TECHNICAL SERVICE BULLETIN

SUBJECT: AIR CONDITIONER PULSATING OR RATTLE NOISE			No: TSB-01-55-006
			DATE: June, 2001
			MODEL: See below
CIRCULATE TO:	<input type="checkbox"/> GENERAL MANAGER	<input checked="" type="checkbox"/> PARTS MANAGER	<input checked="" type="checkbox"/> TECHNICIAN
<input checked="" type="checkbox"/> SERVICE ADVISOR	<input checked="" type="checkbox"/> SERVICE MANAGER	<input checked="" type="checkbox"/> WARRANTY PROCESSOR	<input type="checkbox"/> SALES MANAGER

1997-2001 Montero Sport

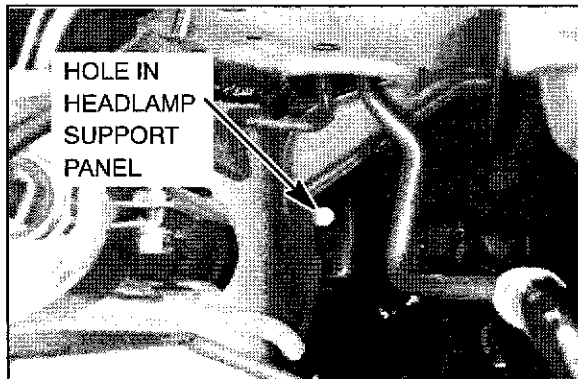
To eliminate a **rattle** noise when the A/C is on, remove the A/C discharge hose bracket.

- a. After removing the bracket, be sure that the A/C discharge hose does not contact any surrounding parts.

- b. Be sure that the A/C discharge hose does not contact the hole in the headlamp support panel.

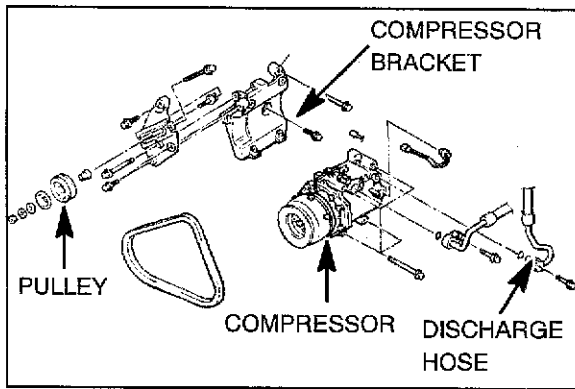
2. **Vehicles Built After 12/97:**

To eliminate a **pulsating** noise when the A/C is on, inspect the A/C bracket. If the bracket is aluminum, replace it with a cast iron bracket and bolt listed in the PARTS INFORMATION section of this bulletin. Refer to Group 55 of the appropriate service manual.

All 2000 and 2001 models produced before 4/12/01 (VIN 1P061090) have the aluminum A/C bracket. Install the cast iron bracket on these vehicles.

Part No.	Description
MR240427	A/C compressor bracket
MF303369	Bolt with washer
